# TRANSIT EFFECTIVENESS PROJECT Final Environmental Impact Report

Volume 2 – Chapter 8: Responses to Comments

**City and County of San Francisco Planning Department  
Case No. 2011.0558E**

Changes from the DEIR text are indicated by a dot (●) in the left margin.

(Revised) FIGURE 23 - TTRP.30 EXPANDED ALTERNATIVE

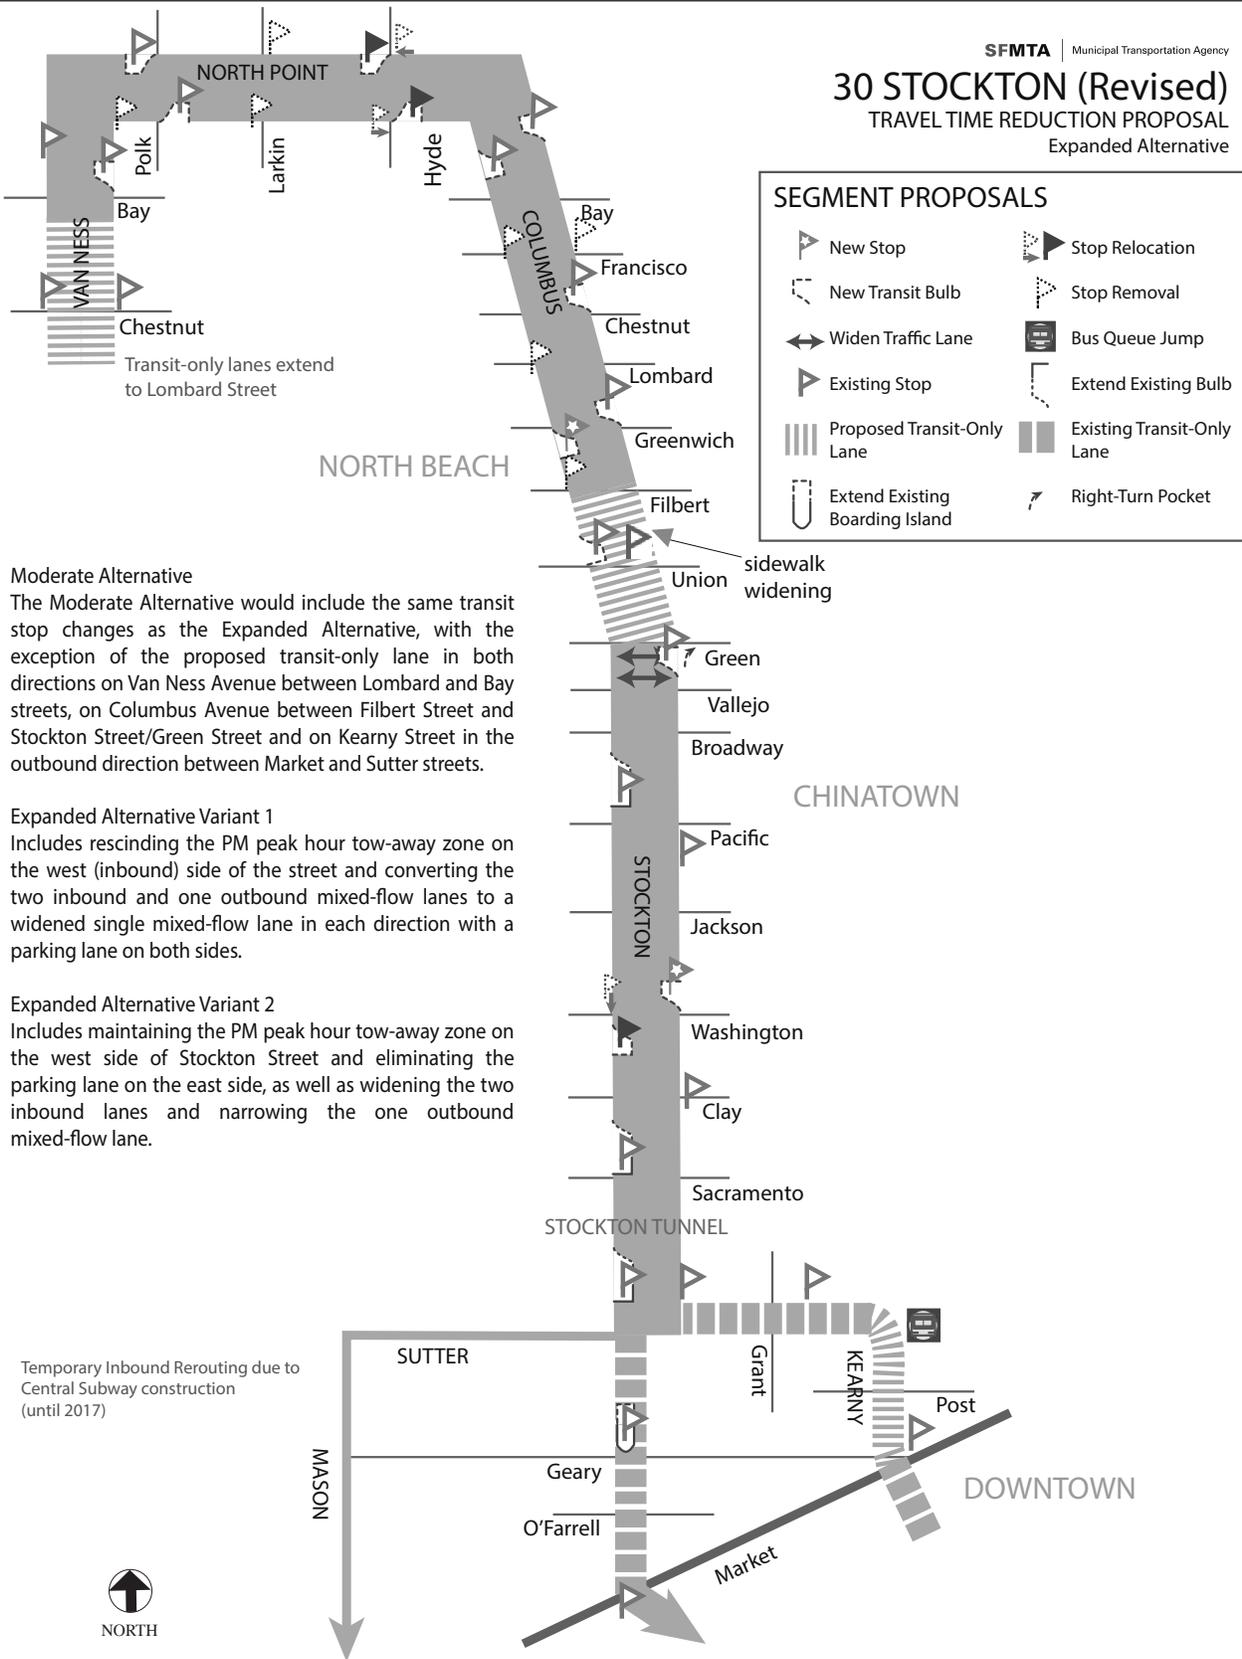
The Expanded Alternative would include all the transit stop changes included in the Moderate Alternative as well as the sidewalk widening along the east side of Columbus Avenue between Union and Powell streets.
- \* Figure 23: TTRP.30 Expanded Alternative on EIR p. 2-160 has been revised to show that under the Moderate and Expanded Alternatives sidewalk widening would occur on the east side of Columbus Avenue on the entire block between Union and Powell streets. Revised Figure 23 is shown on the following page.

(New) FIGURE 23a - TTRP:71\_1 EXPANDED ALTERNATIVE

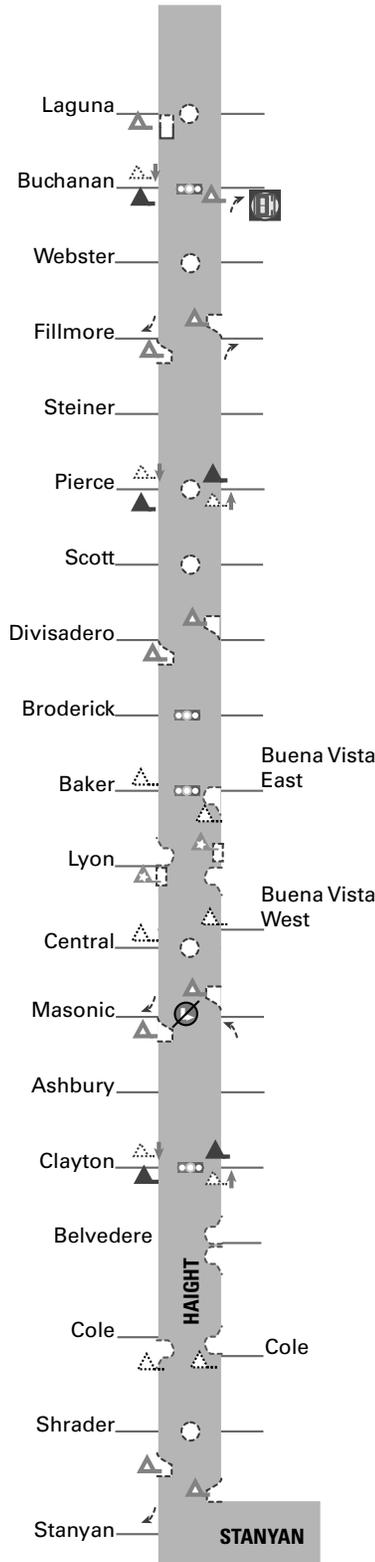
Figure 23a shows TTRP.71\_1 Expanded Alternative and describes the differences between the Moderate and Expanded Alternatives. Please see information and additional graphics illustrating the TTRP.71\_1 project at the SFMTA Web site, online at <http://www.sftepc.com>.

**Line 10 - Sansome**

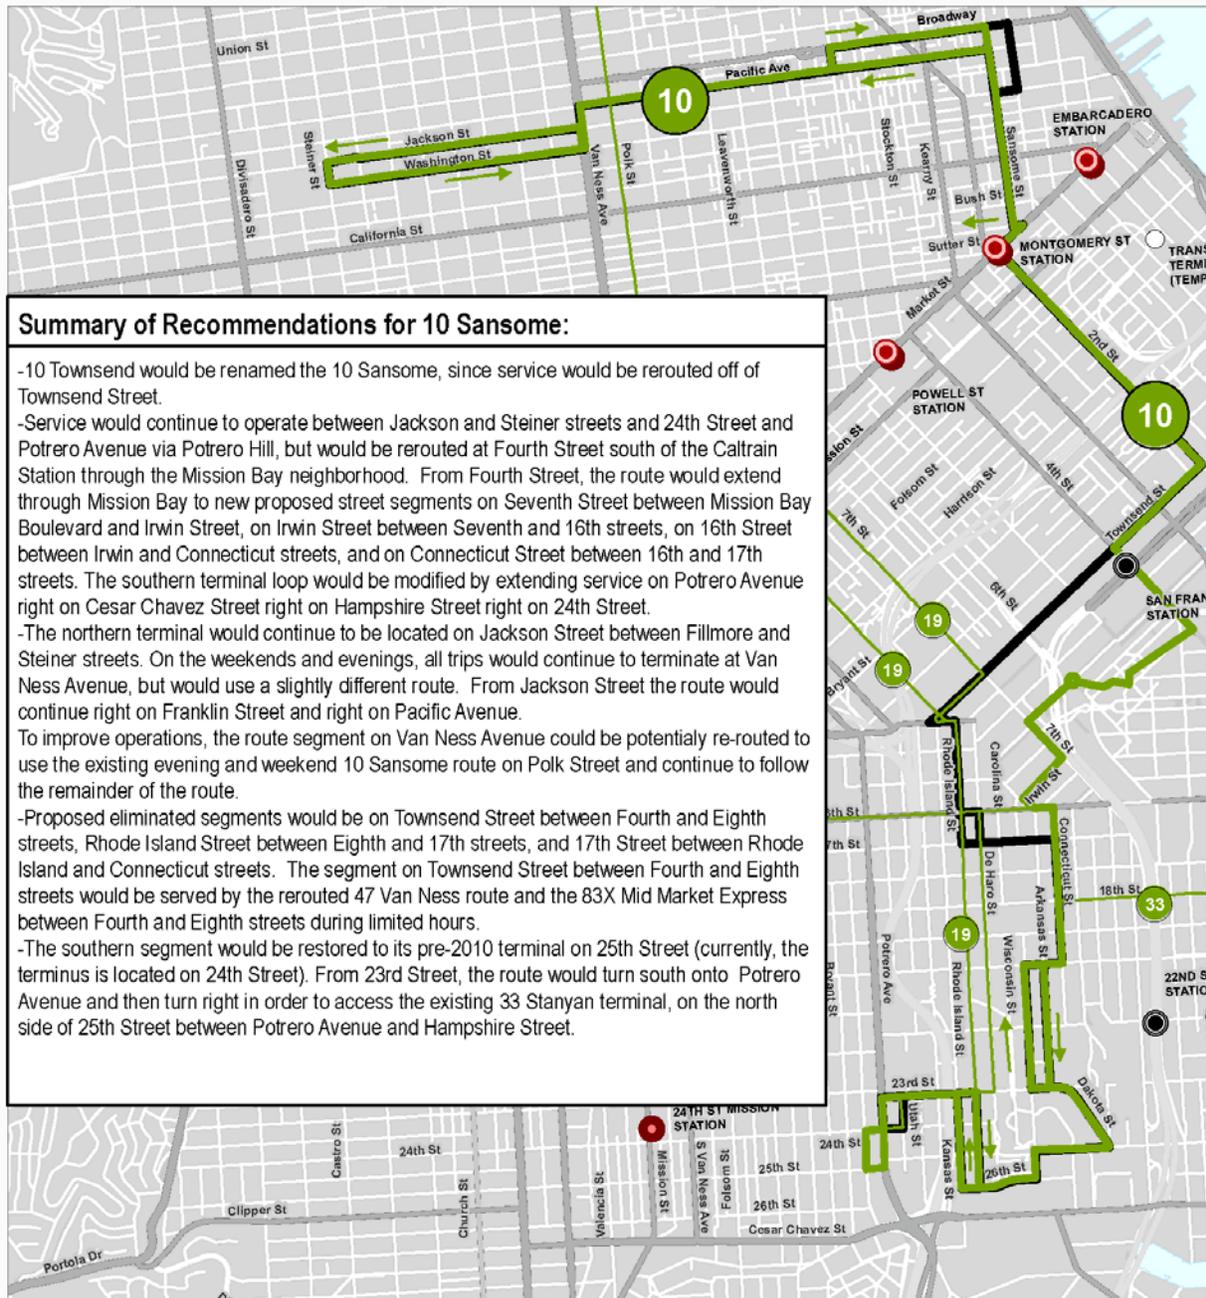
The Line 10 – Sansome Service Improvement Map provided in Initial Study Appendix A, Service Improvement Maps, has been revised to clarify the embedded text and graphic for the weekend and evening variation on the existing loop on the northern segment of the route in the vicinity of Van Ness Avenue.
